Hydrogen-fuelled vehicles (HFCV) practical issue

May 2022

GRSP-71-YY

What does it mean ?

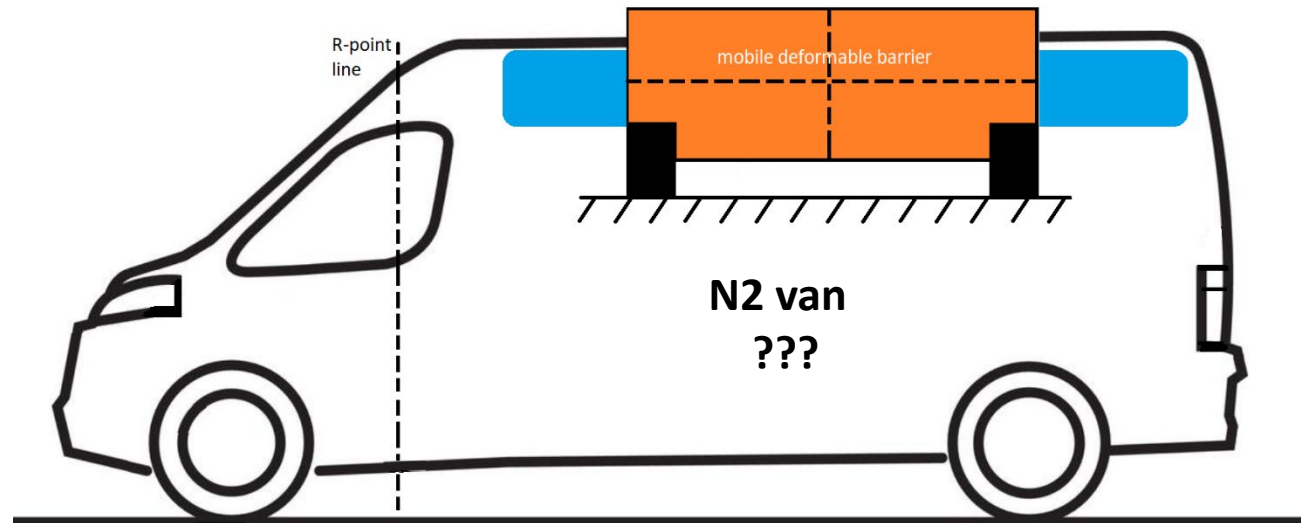
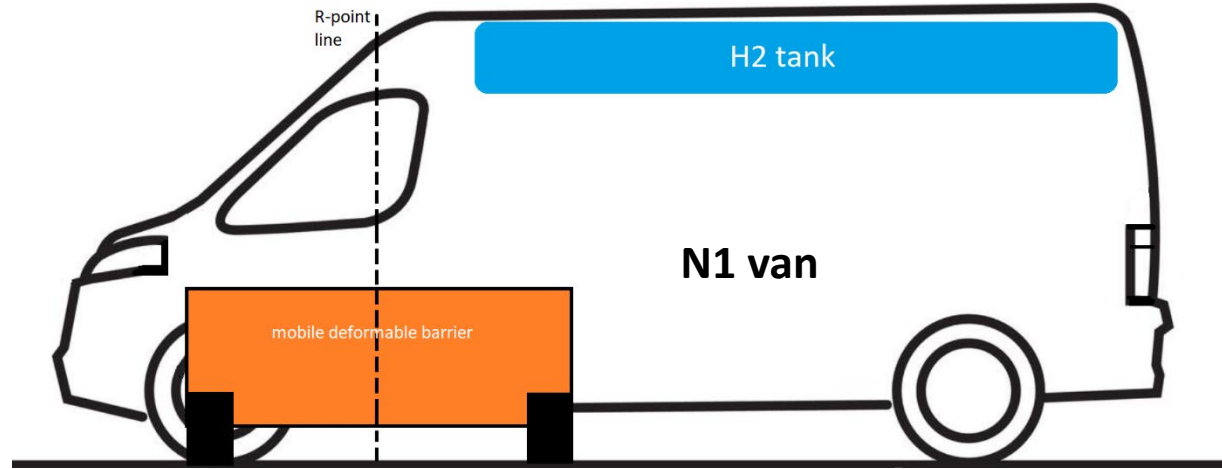
- Testing M1, N1 vehicle according to UN R95
 - vehicle and barrier both on ground level
 - centre of barrier in line with R-point of the driver's seating position (i.e. not related to the position of the hydrogen storage system in the vehicle)

So how to test... ?

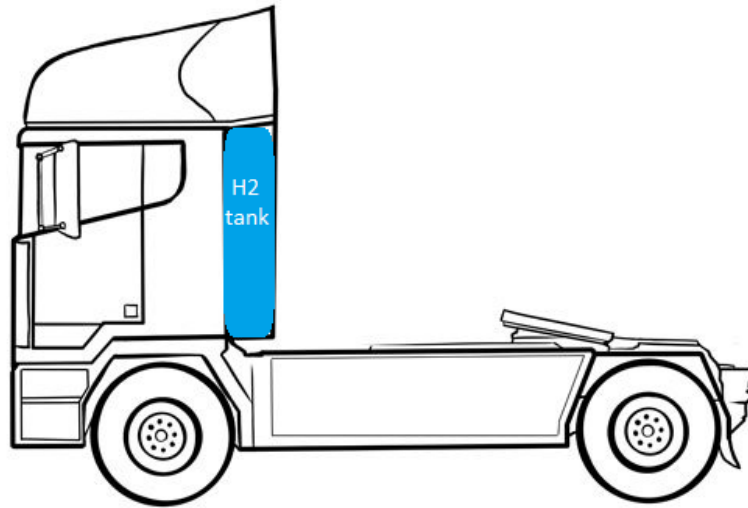
Observations:

- Procedure for vehicles within scope of R95 and outside scope differs
 - no justification
 - not practical

Paragraph 7.2.4.3.3., amend to read

7.2.4.3.3. Lateral impact on compressed hydrogen storage system

The MDB speed at the moment of impact shall be 50 ± 1 km/h. However, if the test was performed at a higher impact speed and the compressed hydrogen storage system met the requirements, the test shall be considered satisfactory. The impact direction shall be in an angle of 90° to the longitudinal axis of the test set-up as defined in paragraph 7.2.4.3.1. and the container shall be adjusted in a way that the middle of the front plate of the barrier matches the middle of the container in the ~~horizontal and~~ vertical axis.
